Addendum No. 2

Bid Documents

FRIENDSHIP FOREST WILDLIFE SANCTUARY

PARK RENOVATION

Double Leg Pedestal (DLP)

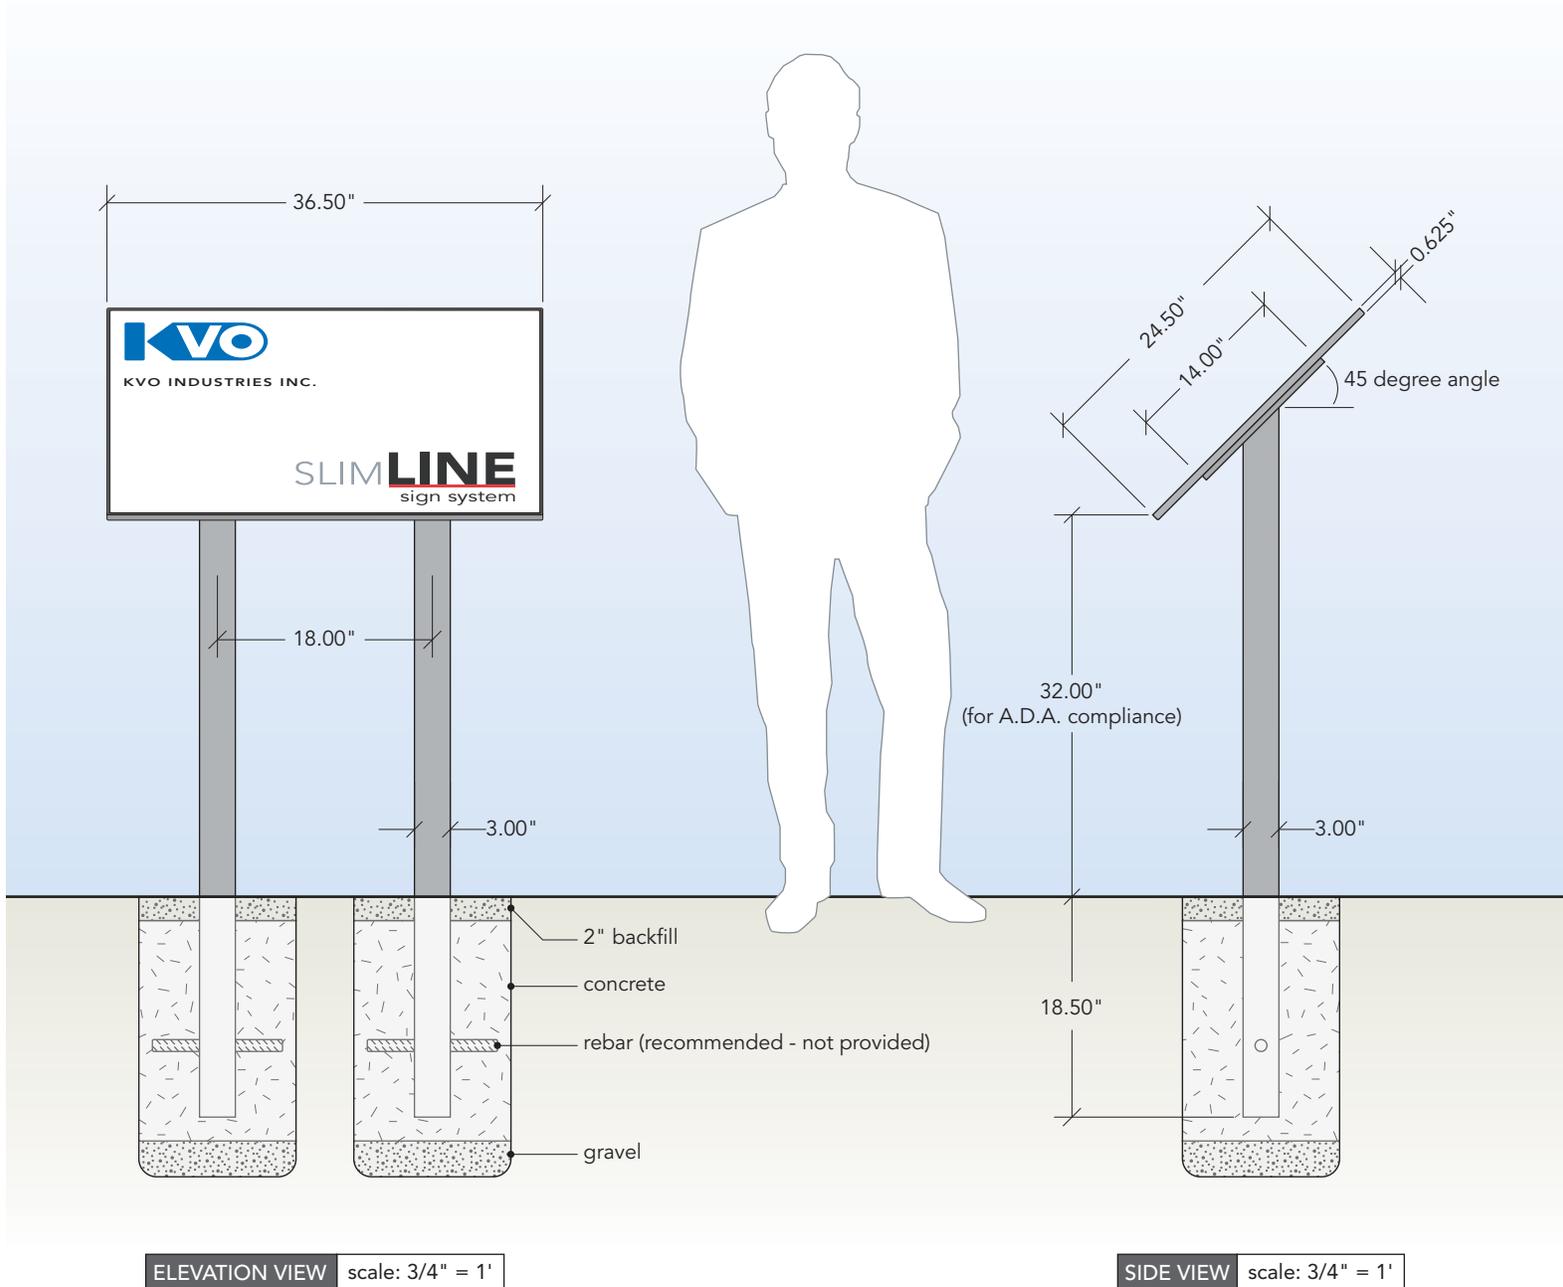
On bid form, under section "Site Elements" on page 18, item number "48", it calls out for "Interpretive Signage with Frame/Stands" (QTY.10). I found (QTY.2) details #4, labeled "Message Sign Detail" on plan page "A3.1" is that the correct detail for the "Interpretive Signage with Frame/Stands"? If yes, where are they located on the plans and how many of each type of "Interpretive Signage with Frame/Stands" there on the plans?

Please refer to the attached cut sheet. Only the pedestals/frames are to be purchased (QTY – 10). No “wording” or other interpretative language/details are to be included as a component of the pedestals
